Tennessee Valley Authority, Post Office Box 2000, Decatur, Alabama 35609-2000

**BROWNS FERRY NUCLEAR PLANT (BFN) - UNITS 1, 2, AND 3 -
TECHNICAL SPECIFICATIONS (TS) CHANGE 403 - INCORPORATION OF
GENERIC TS CHANGES - TS SECTIONS 1.4, 3.0, 3.1.4, AND 5.0 -
TAC NOS. MA9423, MA9424, AND MA9425**

PROPOSED TECHNICAL SPECIFICATIONS (TS) CHANGE TS-403
INCORPORATION OF GENERIC TS CHANGES
TS SECTIONS 1.4, 3.0, 3.1.4, AND 5.0

EXAMPLE B3.0.6-1

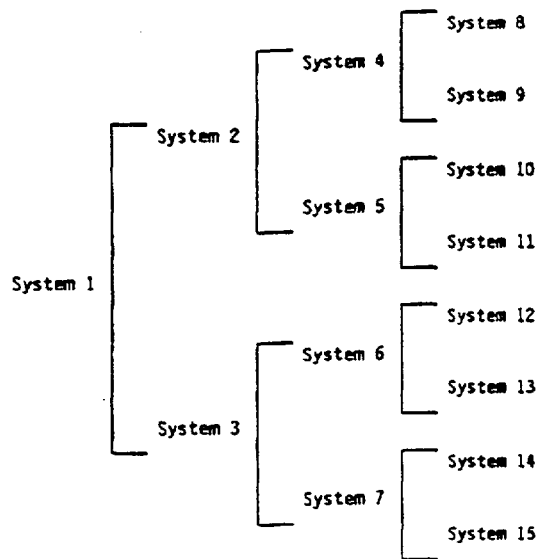
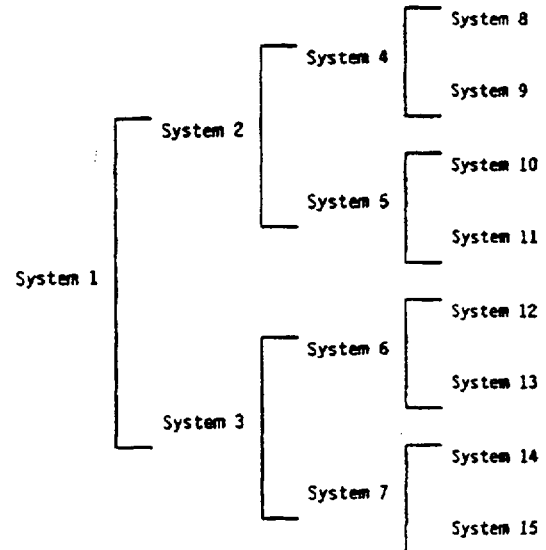
If System 2 of Train A is inoperable, and System 5 of Train B is inoperable, a loss of safety function exists in supported System 5.

Shift operating crew *

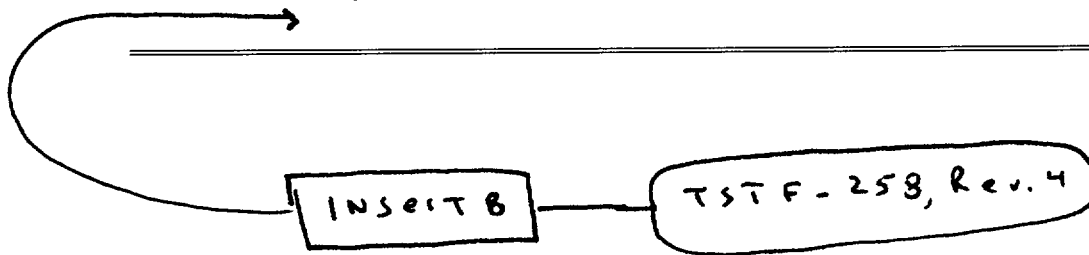
- e. (1) The Operations Superintendent shall hold a current SRO license on a Browns Ferry unit. A - individual
- f. (2) ~~The Shift Technical Advisor (STA)~~ shall provide advisory technical support to the ~~Shift Manager~~ in the areas of thermal hydraulics, reactor engineering, and plant analysis with regard to the safe operation of the unit. ~~In addition, the STA~~ shall meet the qualifications specified by the Commission Policy Statement on Engineering Expertise on Shift.

This individual
